INDESIT company

TCD751EU/HA

F048894

07337-20 Exploded views

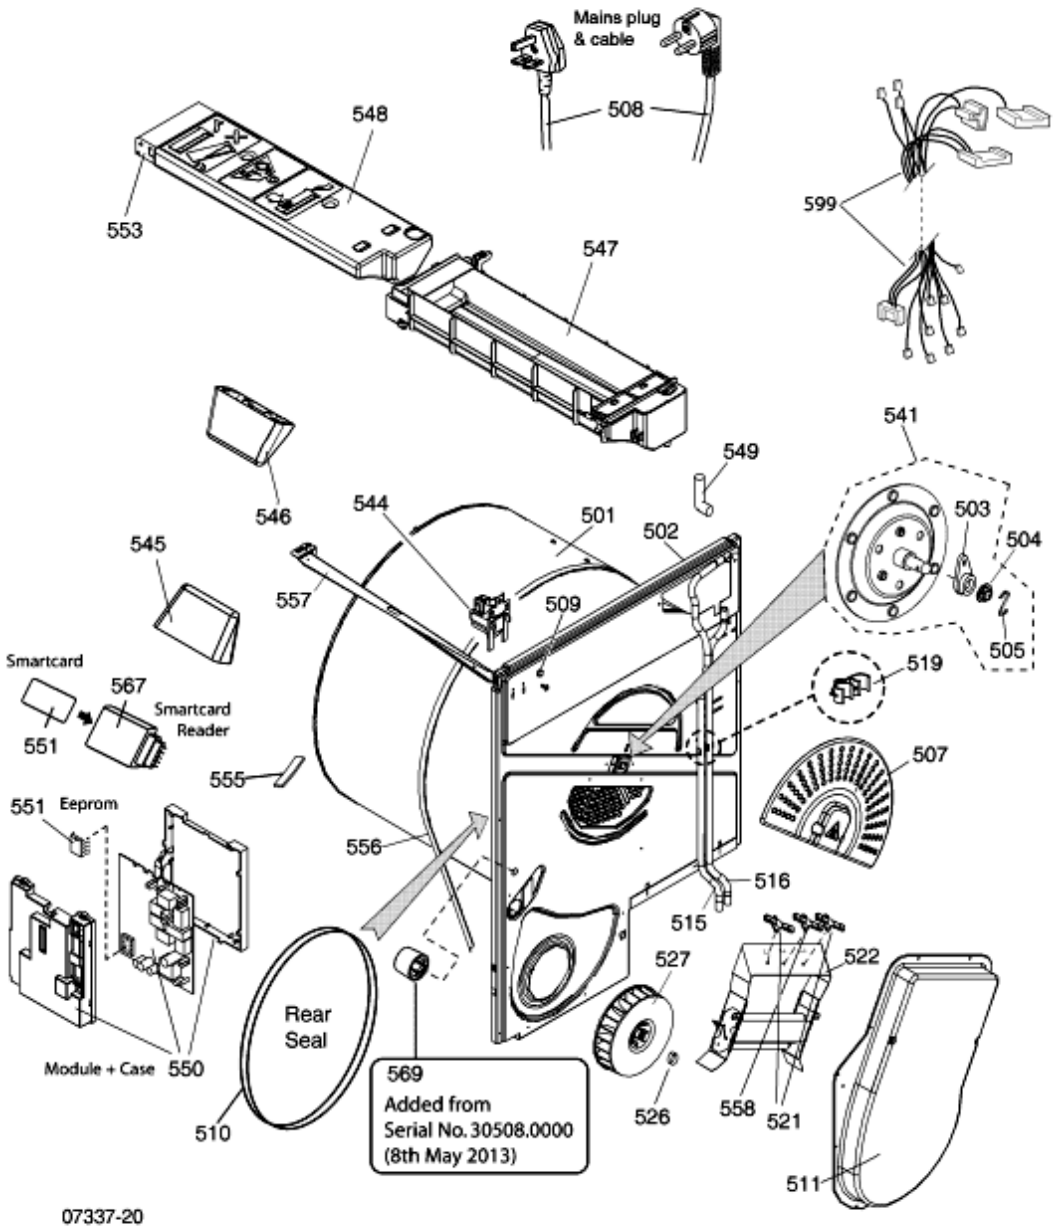
n4408l00: DRUM ASSEMBLY WITH FIXED SHAFT

From Serial Number 80901.0001 a new drum with a fixed (Rivetted) shaft has been introduced in production, this drum is interchangeable and will be supplied as the service spare.

n4411h00: CHANGES TO THE CONDENSER DRUM AND LIFTERS

FROM JULY 2011 THE DRUM FITTED TO ALL CONDENSER TUMBLE DRYERS CHANGED IN PRODUCTION FROM PLAIN TO A PATTERNED FINISH.
WITH THIS CHANGE THE DRUM LIFTERS CHANGED FROM STRAIGHT TO CURVED.

n4413j00: BREAKING BELTS

To overcome the issue of breaking belts the 6 Rib belt has been replaced by the 8 rib belt C00300793

Please Note;
There are 2 drum shaft repair kits
Repair Kit for Drums with a Screwed Drum Shaft
Repair Kit for Drums with a Rivetted Drum Shaft
Select the correct kit from the parts list

Note: Only use the correct kit for the Drum fitted to the Dryer.

THE PATTERNED DRUM AND CURVED DRUM LIFTER WILL BECOME THE SERVICE SPARE PARTS ONCE STOCK OF THE ORIGINAL DRUM AND LIFTERS ARE EXHAUISTED.

07390-05 Exploded views

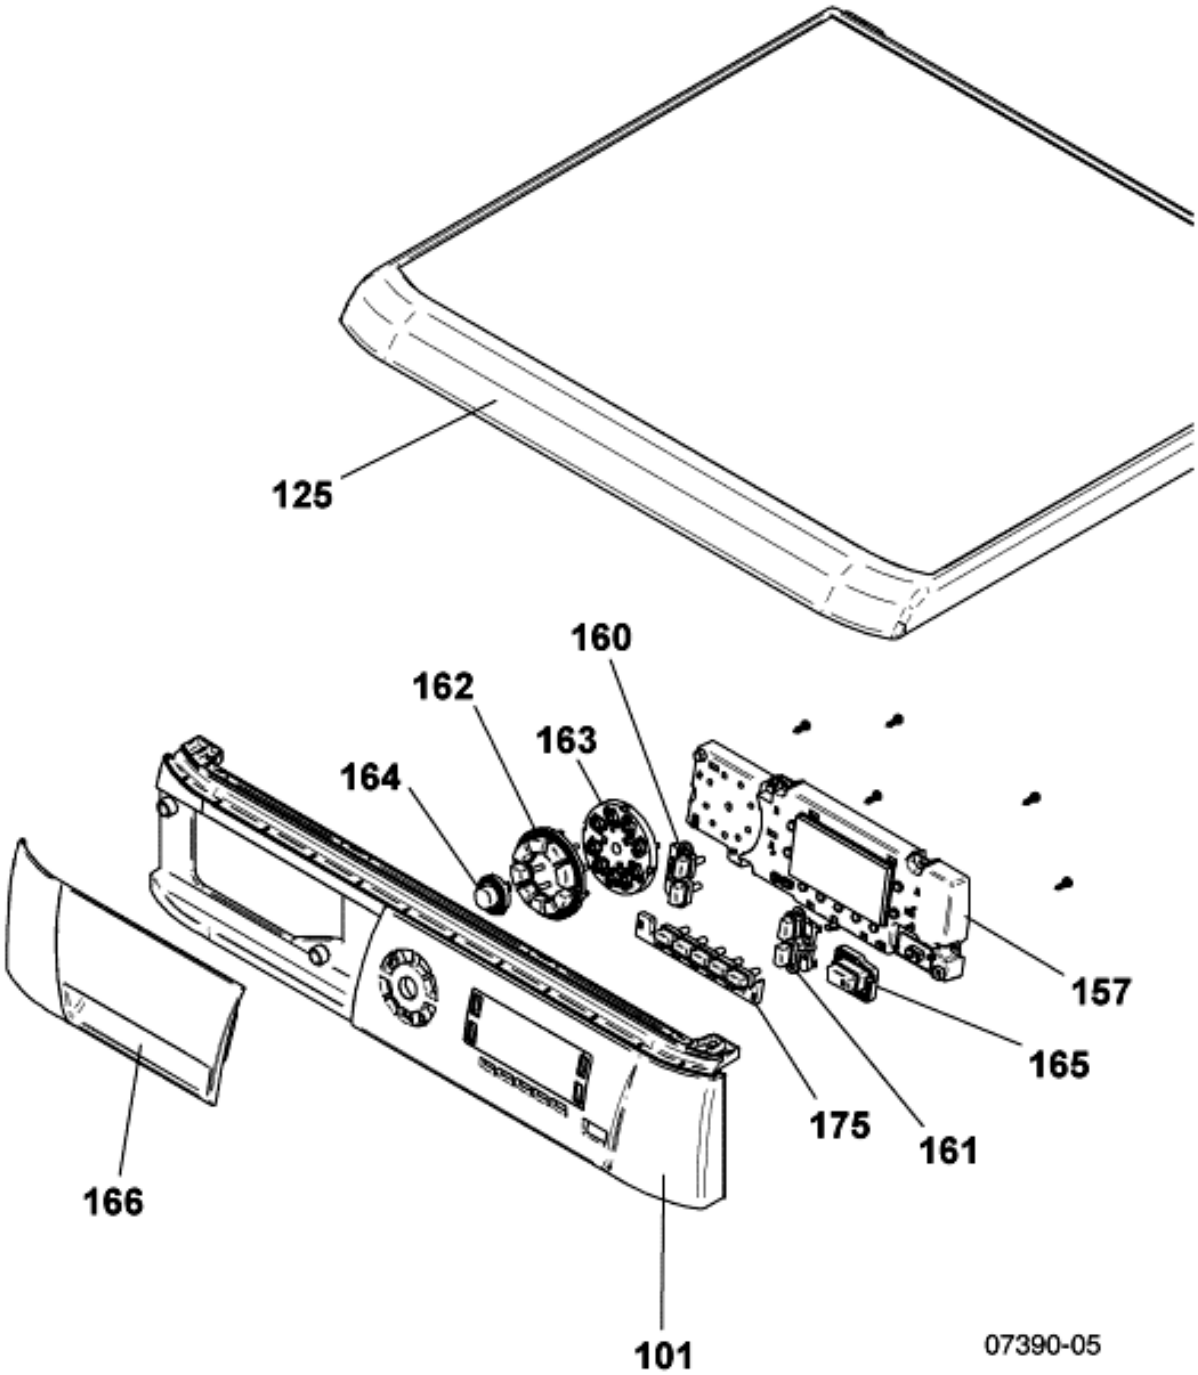
n4409k01: Introduction of Interface Module with Stand–By

From serial number 91102.0001 a new interface module with ‘Stand-By’ was introduced on production and is fitted to all electronic tumble dryers. The "Stand-By" mode is activated after the machine has finished the programme. This module can be used as a direct replacement for the version without Stand-By.

12721-25 Exploded views

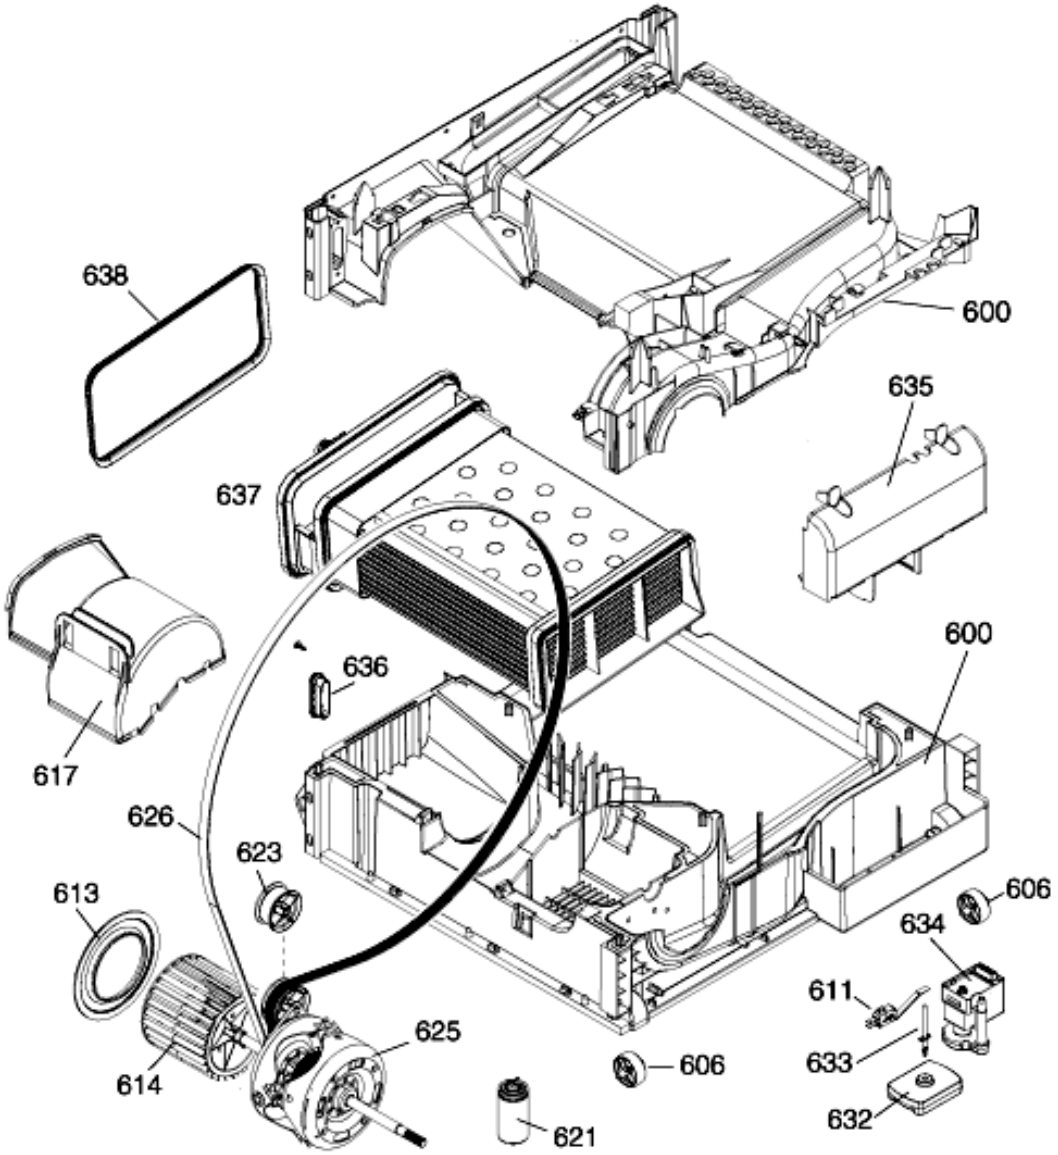
n4409c00: TUMBLE DRYER COOLING FANS

Models with a Serial Numbers from 60917.0000

From 4th March 2008 a 72mm cooling fan has replaced the original 100mm Cooling fan in production.
This Smaller cooling fan is perfectly interchangeable with the 100mm Cooling Fan
